RADFORD ARMY AMMUNITION PLANT, VIRGINIA

Master Work Plan Addendum 19:

07-160

Re: Radford Army Ammunition Plant, Va.
Master Work Plan Addendum 019
Review of the Army's RCRA Work Plan Addendum

FIGURE 2
NEW RIVER AND TRIBUTARIES
SAMPLE LOCATION MAP

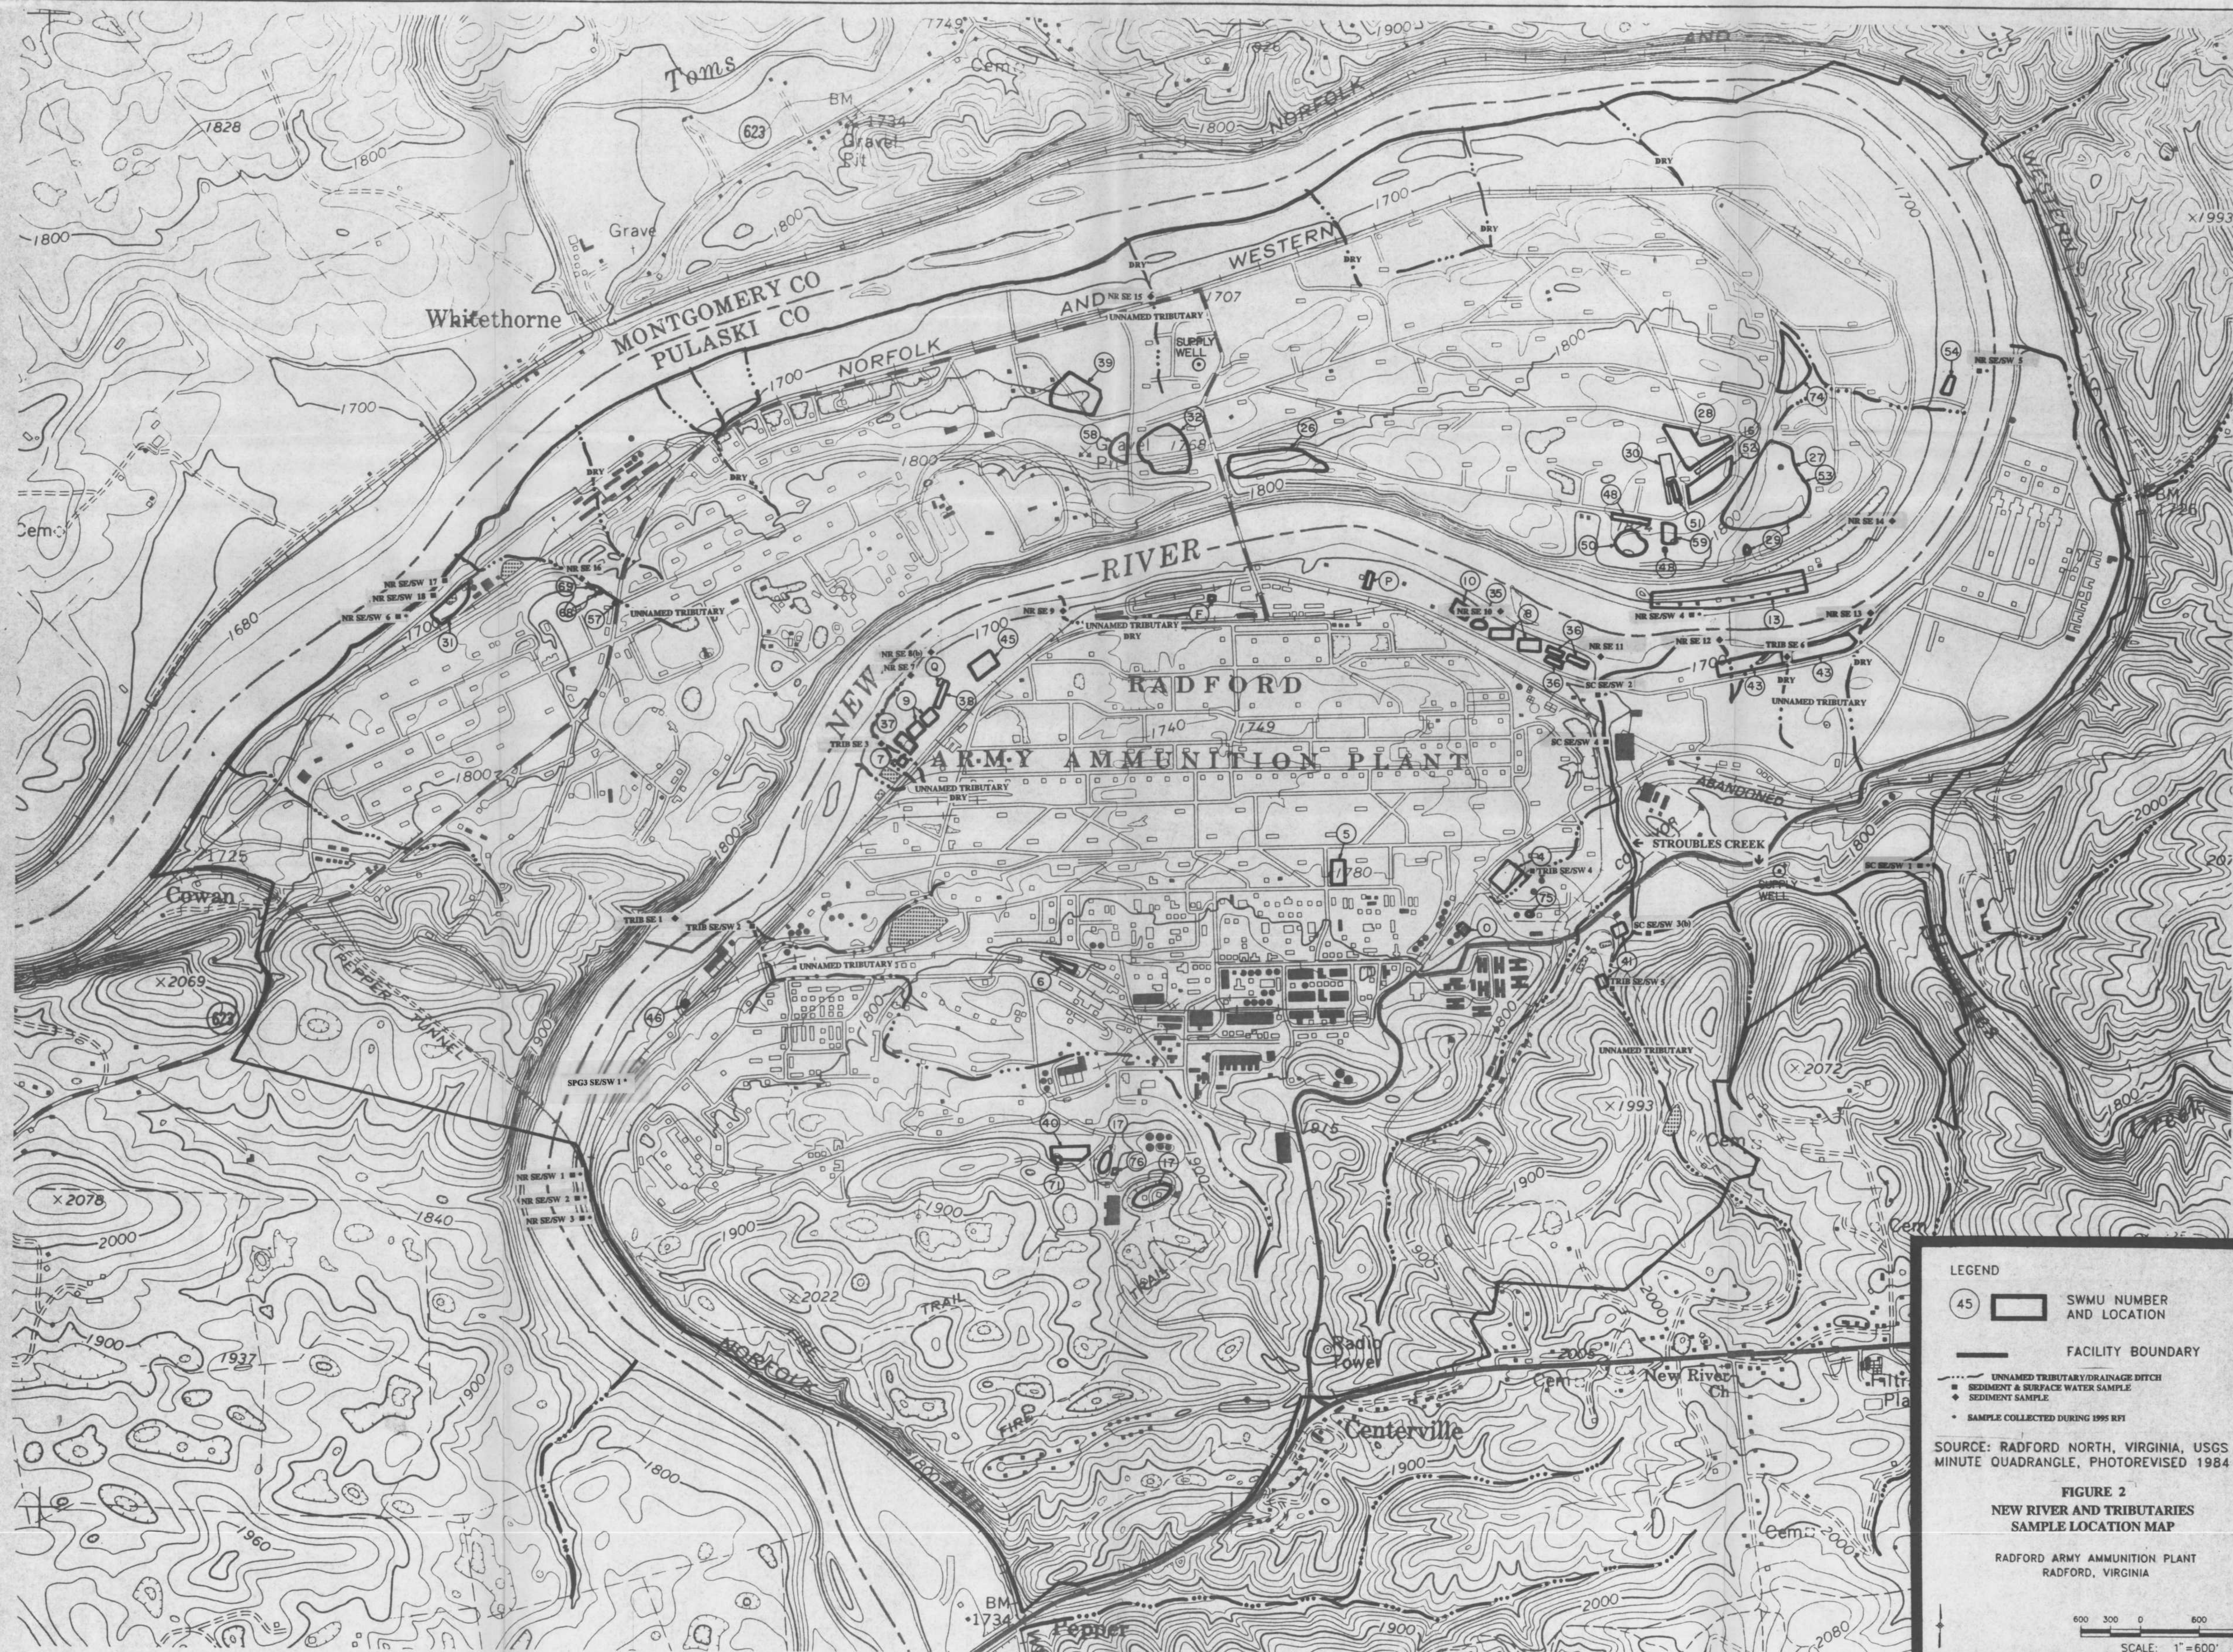
- 1) EPA agrees with the RTCs for comments 1-11.
 - Boring Logs (comment #3) will be sent shortly.
- 2) Comment #12 has been dropped by the EPA.
- 3) EPA agrees with the RTCs for comments 13-17.
 - Revised Figure 3-2 (comment #14) will be sent shortly. An older figure that shows the location of the requested features is attached.

FIGURE 2-2

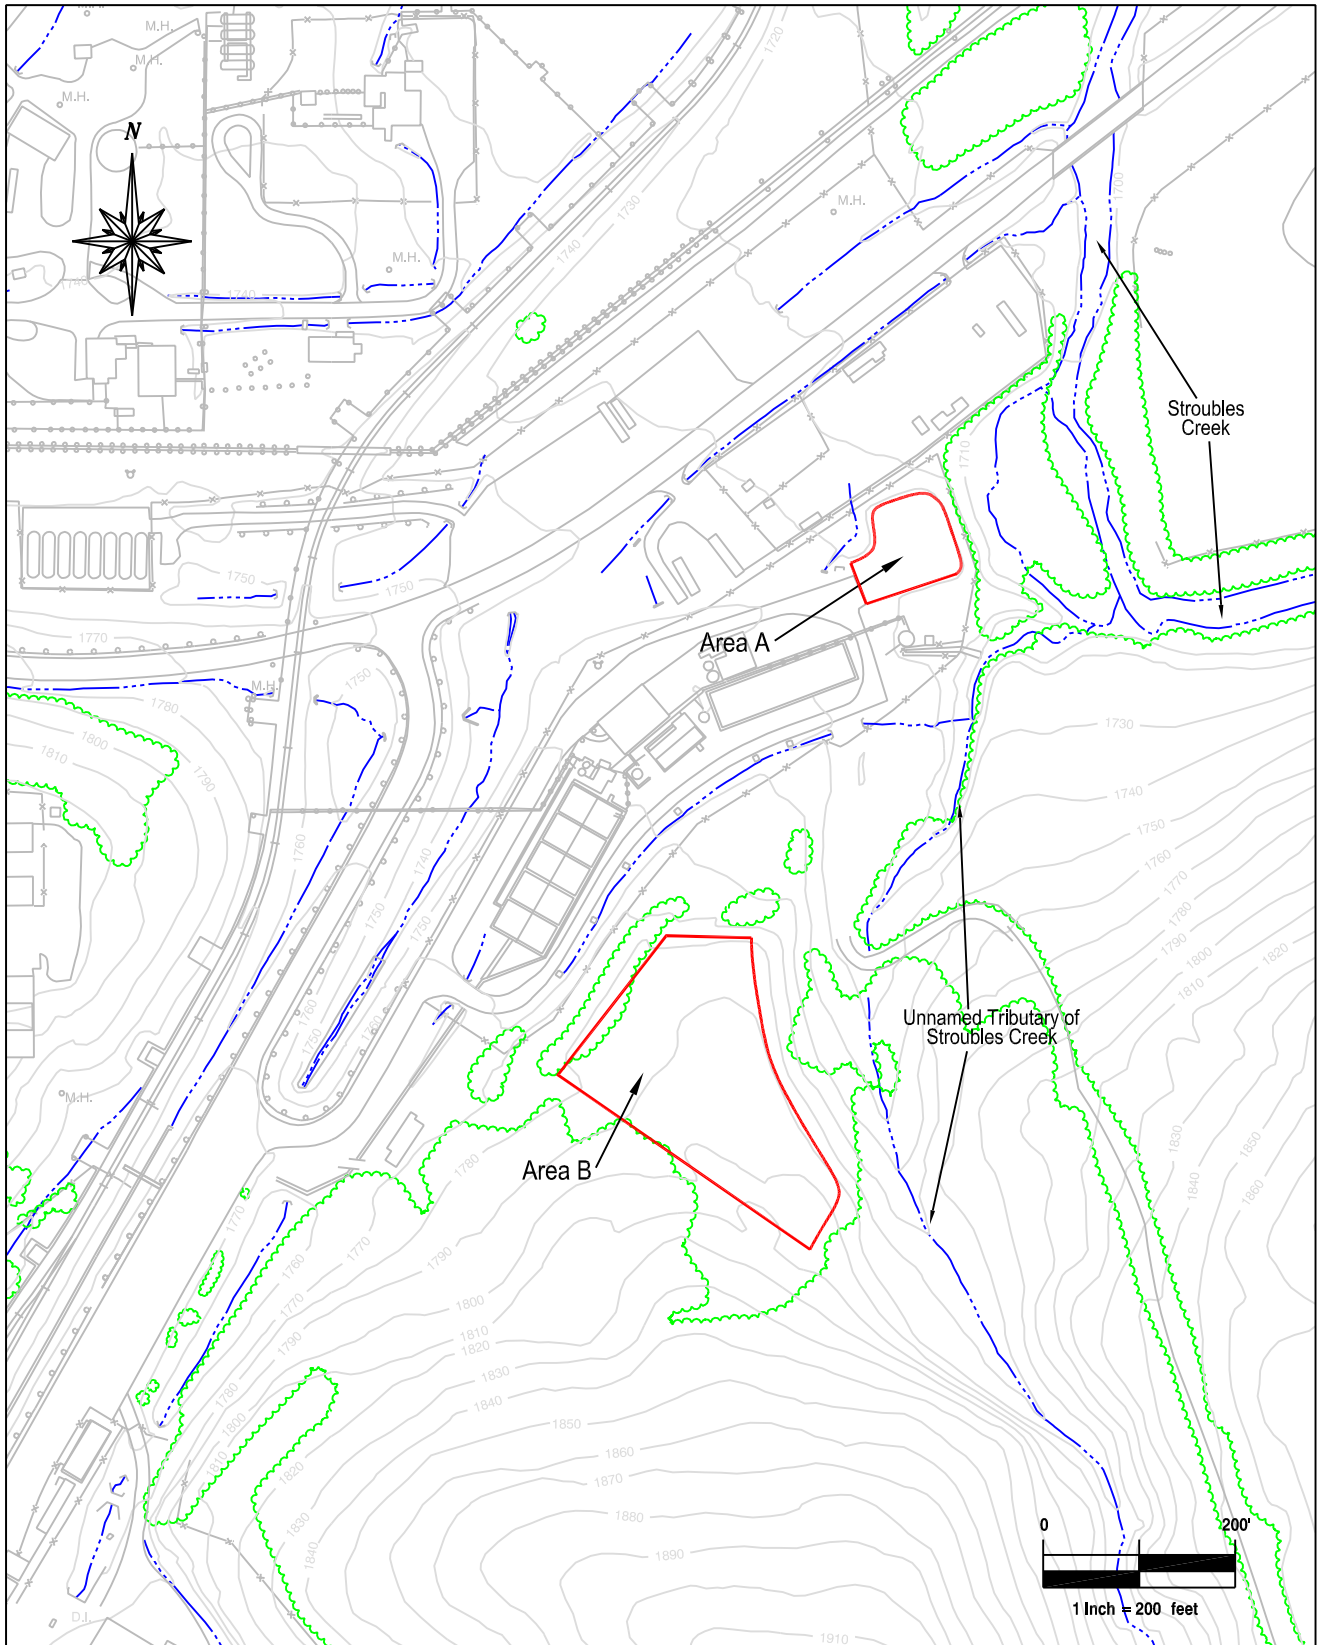
Section 2.1.1, Site Description, Page 2-1. The text states that a 1986 aerial photo is shown on Figure 2-2; however, a note on Figure 2-2 indicates that the source of the figure is a May 25, 2000 aerial photo. Revise the Work Plan Addendum to resolve this discrepancy.

Section 2.5, Data Gap Analysis, Soil, SWMU 49, Page 2-35. Figure 2-2 appears to show that most of the previous sampling at this site is concentrated in the western half of the solid waste management unit (SWMU) (with the exception of one surface soil sample on the southeastern side). Additional information for this sampling approach has not been provided. Revise the Work Plan Addendum to address this apparent data gap. Additional surface and/or subsurface samples may be necessary to characterize the eastern half of SWMU 49.

8. Section 2.1.1, Site Description, Page 2-1. The text states that a 1986 aerial photo is shown on Figure 2-2; however, a note on Figure 2-2 indicates that the source of the figure is a May 25, 2000 aerial photo. Revise the Work Plan Addendum to resolve this discrepancy.

9. Section 2.5, Data Gap Analysis, Soil, SWMU 49, Page 2-35. Figure 2-2 appears to show that most of the previous sampling at this site is concentrated in the western half of the solid waste management unit (SWMU) (with the exception of one surface soil sample on the southeastern side). Additional information for this sampling approach has not been provided. Revise the Work Plan Addendum to address this apparent data gap. Additional surface and/or subsurface samples may be necessary to characterize the eastern half of SWMU 49.

Figure 3-3
SWMU 41
Geologic Cross Section
A-A'

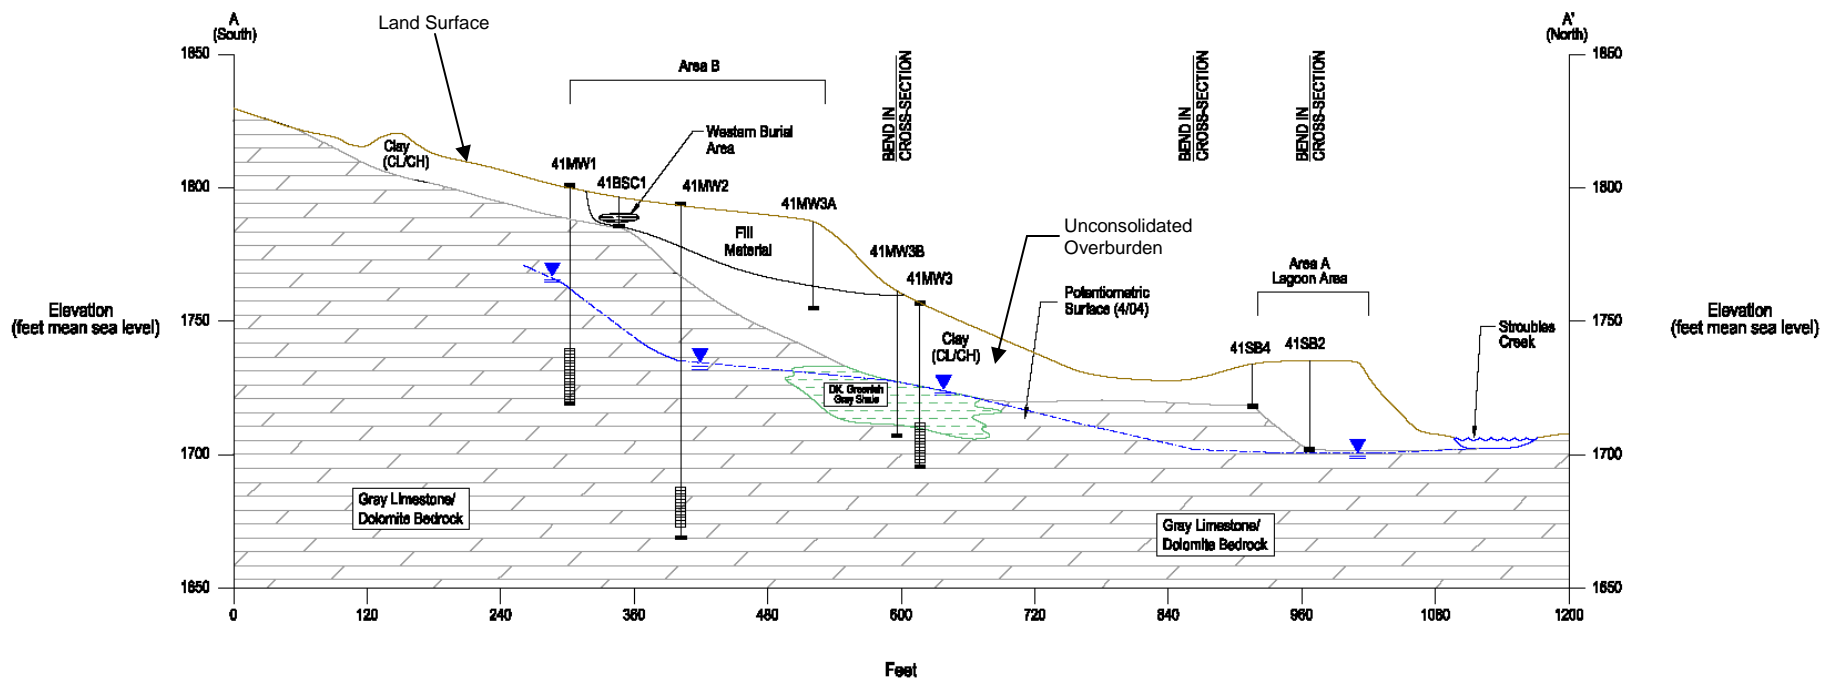
Section 3.6, Investigation Approach, Area A, Page 3-43. It is not clear that the proposed method for collecting groundwater samples (direct push method) is appropriate for this site. Figure 3-3 (SWMU 41 Geological Cross Section) appears to show that the water table is located at or below the top of the bedrock/overburden interface. Direct push sampling is typically used for sampling in the overburden.

21. Section 3.6, Investigation Approach, Area A, Page 3-43. It is not clear that the proposed method for collecting groundwater samples (direct push method) is appropriate for this site. Figure 3-3 (SWMU 41 Geological Cross Section) appears to show that the water table is located at or below the top of the bedrock/overburden interface. Direct push sampling is typically used for sampling in the overburden. Alternative drilling methods may need to be proposed in order to obtain the groundwater samples. Permanent wells should be considered as they will allow for future monitoring and trend analysis, if contaminants of concern are identified. Realize we discussed at meeting, just putting it out there - Will

Figure 4-3

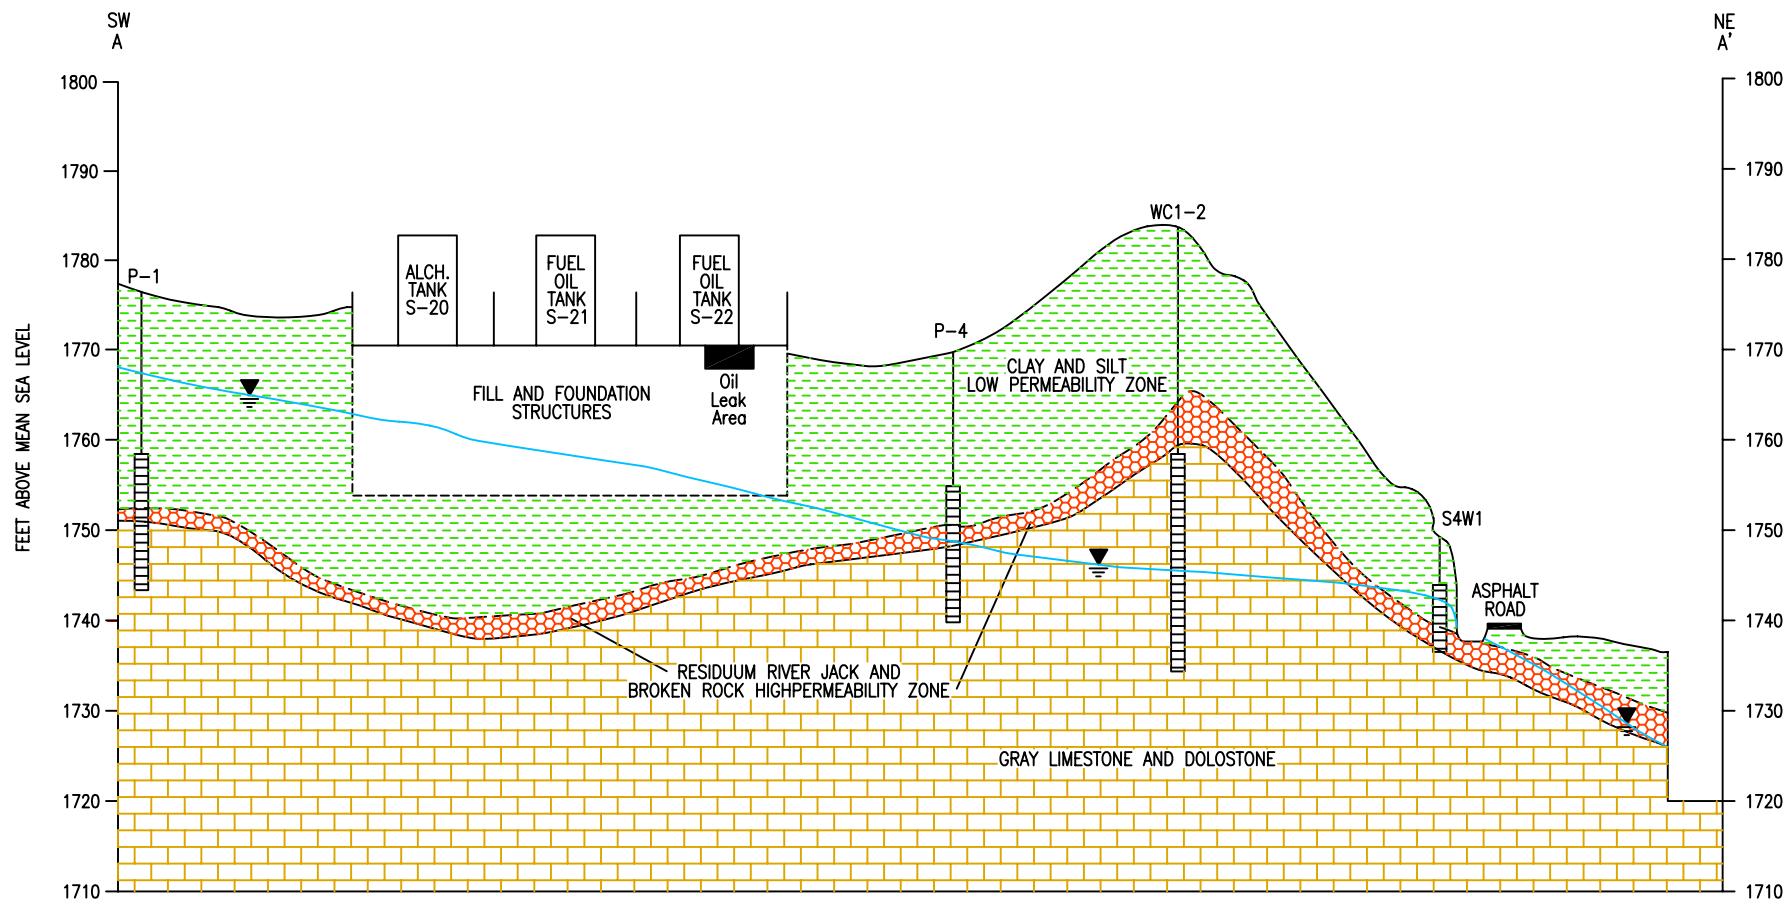
Section 4.6, Investigation Approach, Groundwater, Page 4-22. The Work Plan Addendum proposes to collect additional groundwater samples using direct push technology. However, based on the anticipated depth to bedrock at this site, it is not clear that this methodology will be appropriate. Figure 4-3 (Cross Section A-A', Area O) appears to show that the water table is located within bedrock at existing monitoring well WC1-2, which is located in the same area for which the direct push sampling is proposed (Figure 4-2). Direct push sampling is typically used for sampling in the overburden, not bedrock. Revise the Work Plan Addendum to address this concern. Alternative drilling methods should be considered in order to obtain the proposed groundwater samples.

Work Plan Addendum proposes to collect additional groundwater samples using direct push technology. However, based on the anticipated depth to bedrock at this site, it is not clear that this methodology will be appropriate. Figure 4-3 (Cross Section A-A', Area O) appears to show that the water table is located within bedrock at existing monitoring well WC1-2, which is located in the same area for which the direct push sampling is proposed (Figure 4-2). Direct push sampling is typically used for sampling in the overburden, not bedrock. Revise the Work Plan Addendum to address this concern. Alternative drilling methods should be considered in order to obtain the proposed groundwater samples.
